Office Furniture RFP Questions & Answers

MEYDENBAUER OFFICES - LEVEL 3

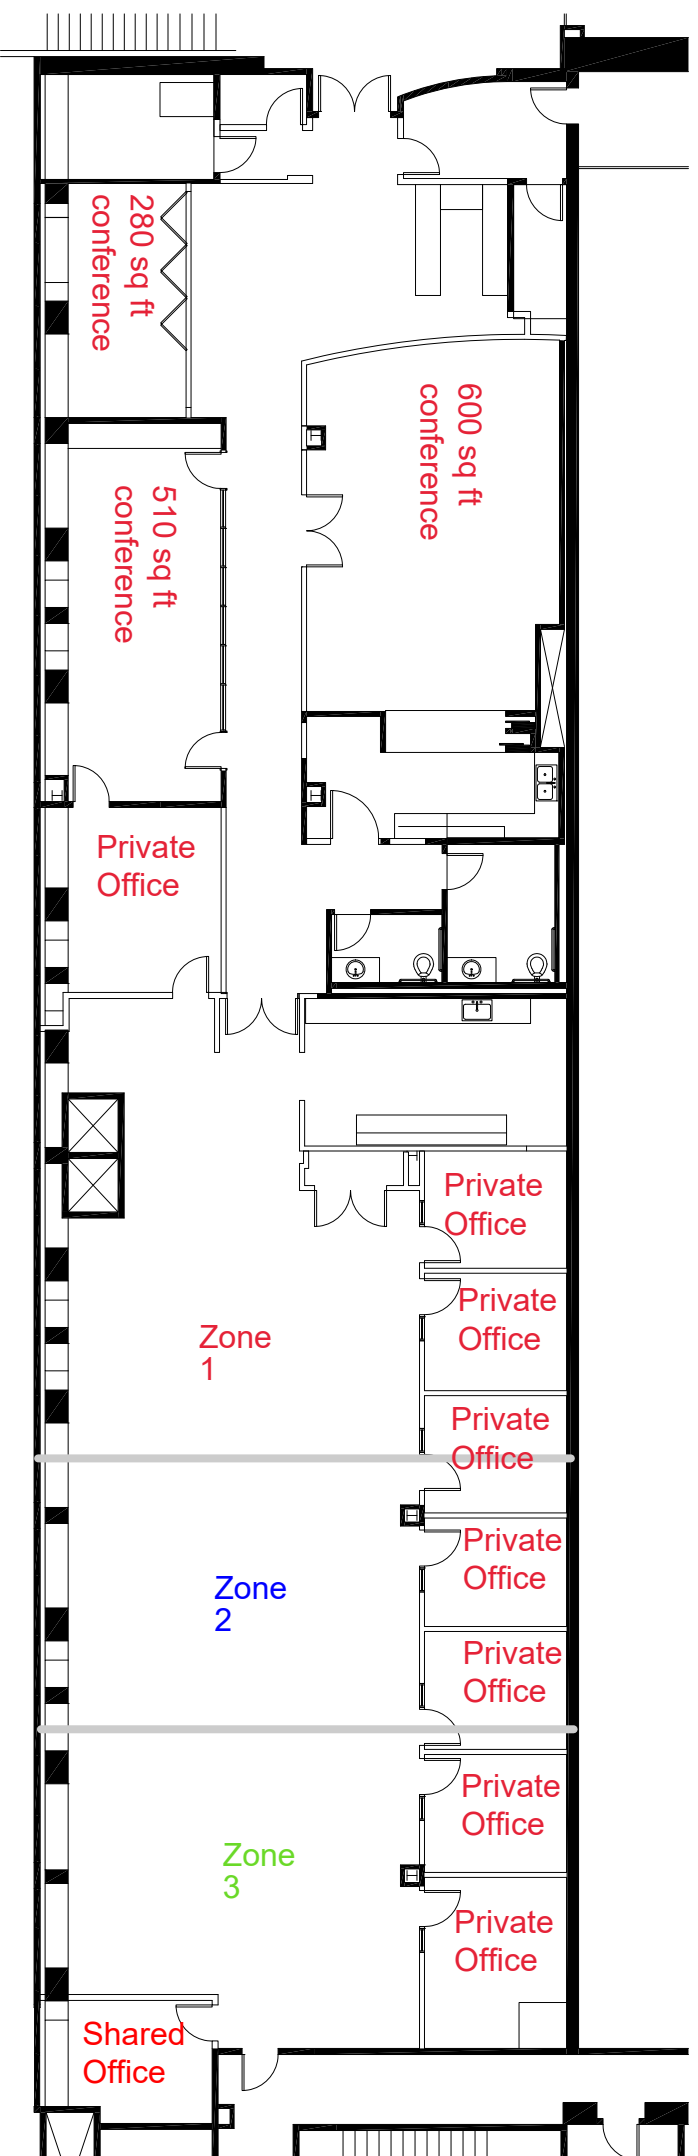
11. Can you indicate where the third conference room is?

12. Can you indicate where the shared office space is?

Answer: The locations are marked in the second page of this document.

Answer: The location is marked on the second page of this document. We are going to expand the space. We have one additional private office that is much larger that falls outside the diagram, but the furniture can match what is in the smaller offices on the diagram.
